Project	IEEE 802.16 Broadband Wireless Access Working Group < http://ieee802.org/16 >	
Title	Preamble, FCH and MAPs Transmission in Transparent Relay Station	
Date Submitted	2007-03-06	
Source(s)	Young-jae Kim, Kyu Ha Lee, Jae Hyung Eom, Changkyoon Kim Samsung Thales San 14, Nongseo-Dong, Giheung-Gu, Yongin, Gyeonggi-Do, Korea 449-712	Voice: +82-31-280-9975 Fax: +82-31-280-1562 youngjae2.kim@samsung.com kyuha.lee@samsung.com
	Byung-Jae Kwak, Su Chang Chae, Young-il Kim ETRI 161, Gajeong-Dong, Yuseong-Gu, Daejeon, Korea 205-350	Voice: +82-42-860-6618 Fax: +82-42-861-1966 bjkwak@etri.re.kr
Re:	Call for Technical Proposal regarding IEEE Project P802.16j	
Abstract	The document contains technical proposals for IEEE P802.16j that provides a frame structure.	
Purpose	This is a response to Call for Technical Proposals regarding IEEE Project P802.16j.	
Notice	This document has been prepared to assist IEEE 802.16. It is offered as a basis for discussion and is not binding on the contributing individual(s) or organization(s). The material in this document is subject to change in form and content after further study. The contributor(s) reserve(s) the right to add, amend or withdraw material co

Figure 1. Example of a preamble, FCH, and MAPs transmission in transparent RS

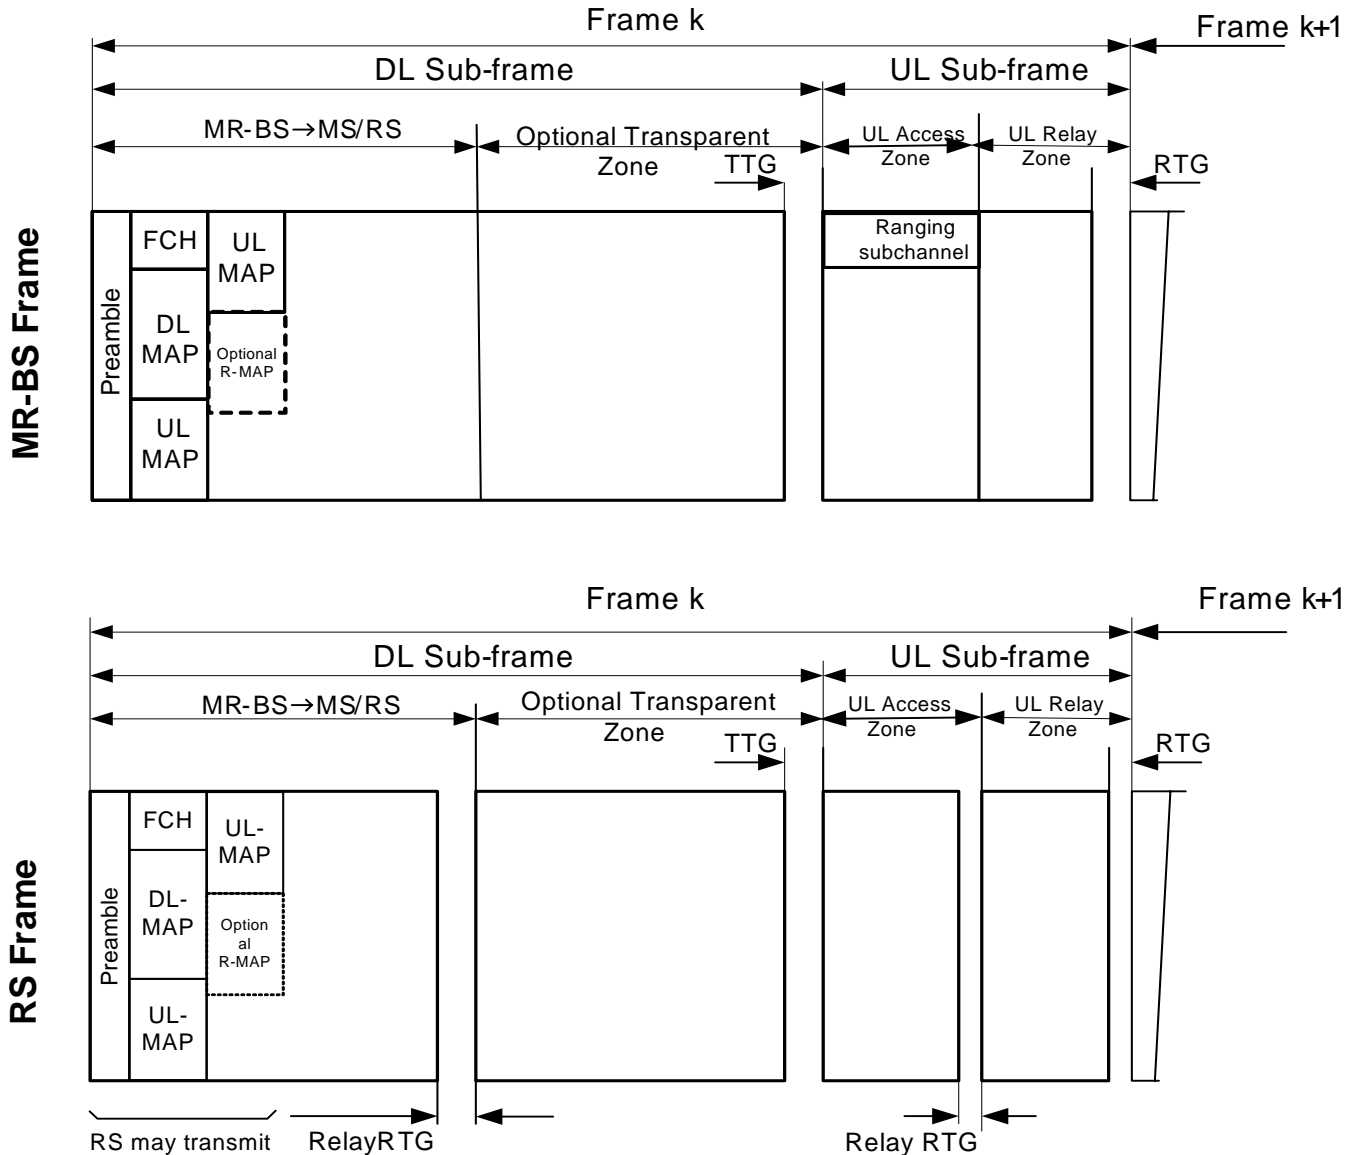
This proposal suggests that a transparent RS may transmit a preamble, FCH and MAPs that are same with those of MR-BS.

Figure xxx. Example of configuration for a transparent relay frame structure

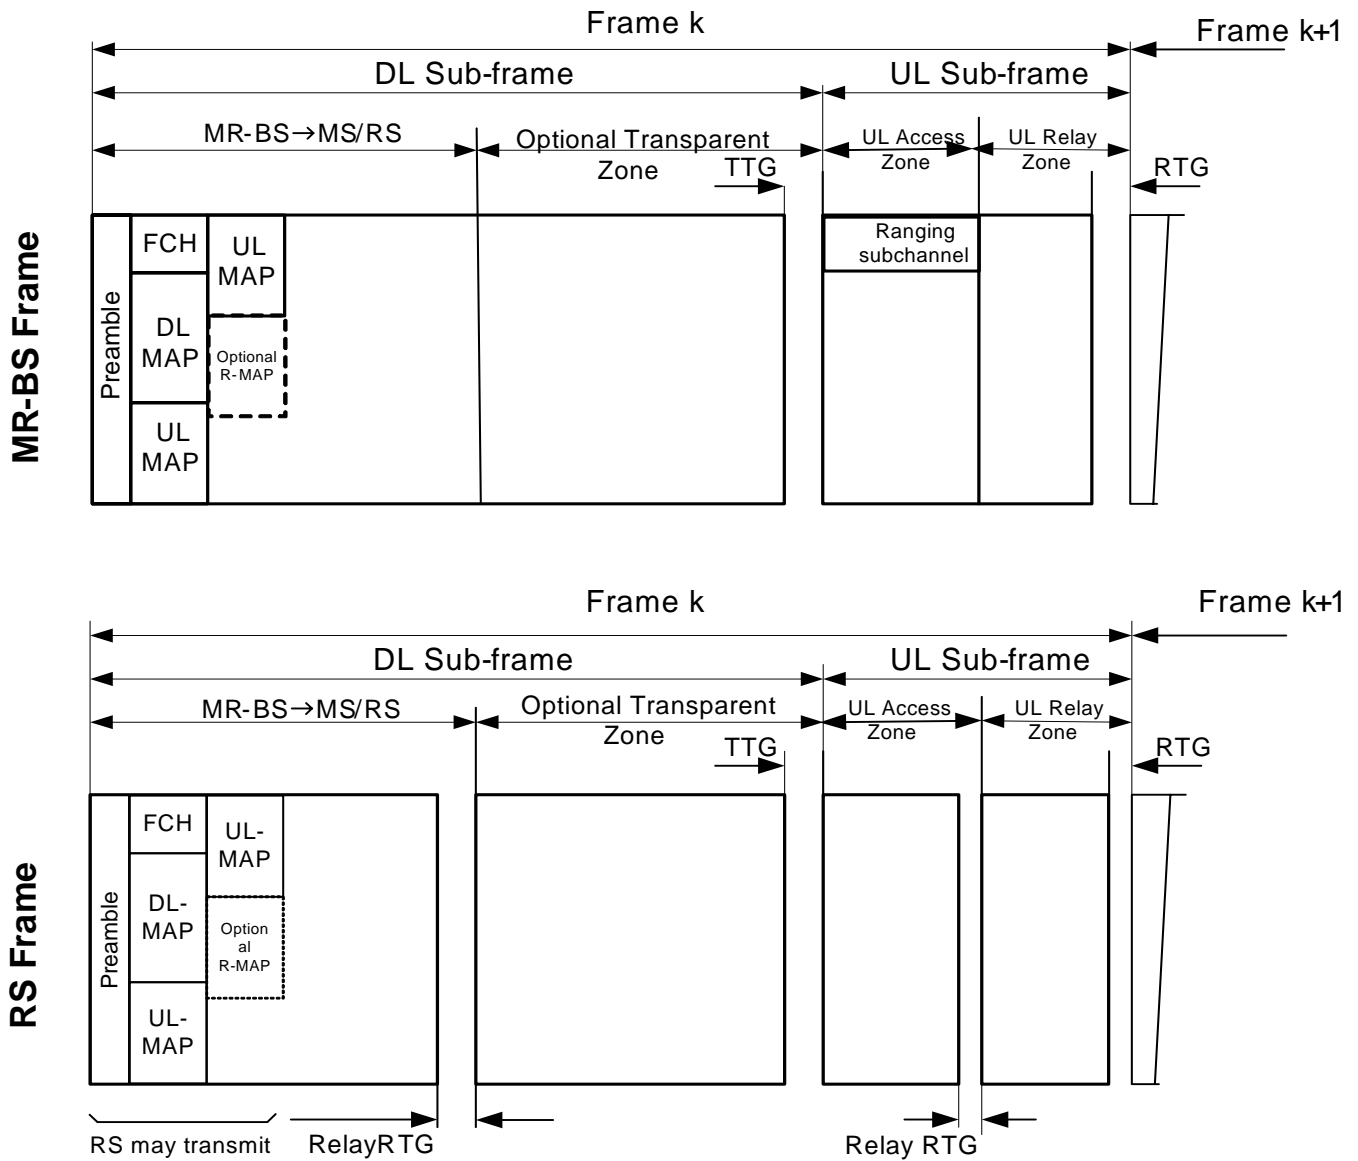
[Replace Figure xxx at section 8.4.4.7.1.1]

For a transparent RS, the preamble and MAP are basically not transmitted at the beginning of the frame. Instead it listens the preamble, MAP or optional R-MAP transmission from MR-BS. But optionally transparent RS ma

y transmit the preamble, FCH and MAPs which are same with those of MR-BS. The detailed allocation for RS can be indicated by MAP or R-MAP. The signaling method shall be negotiated in RS network entry procedure. In each frame, the TTG shall be inserted between the DL sub-frame and the UL sub-frame. The RTG shall be inserted at the end of each frame.
